## Product Change Notice (PCN)

**PCN Number:** PCN-0450726R-01

**Product(s) Affected:** PJ-002AH-SMT-TR, PJ-002BH-SMT-TR

Current version	New version
Outlook	 <p>housing</p>	 <p>housing</p>
	 <p>pin# 3</p>	 <p>pin# 3</p>

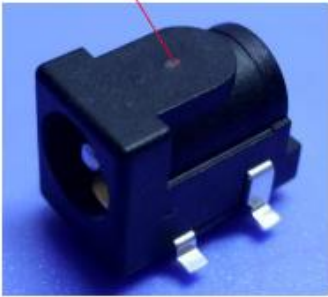
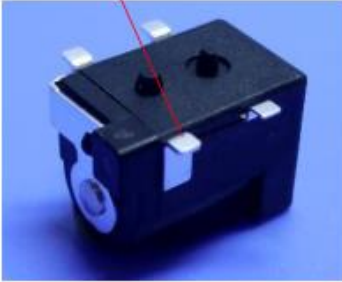
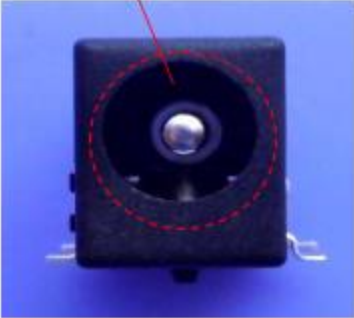
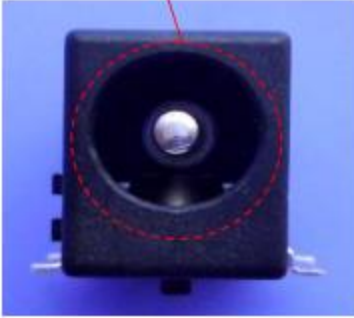
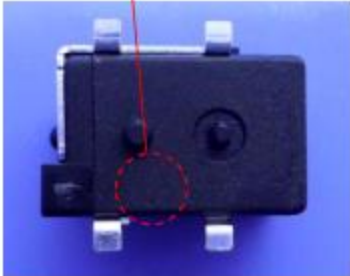
**Reason(s) for Change:** existing plastic housing and pin 3 molds cannot maintain efficient production.

**Description of Change:** to ensure quality and production efficiency, new mold development is in process. Aesthetic changes as shown below. Electrical structure and function remain unchanged.

Front	<p>jack hole without chamfer</p> 	<p>jack hole with chamfer</p> 
Bottom	<p>without cave marking</p> 	<p>cave marking location</p>
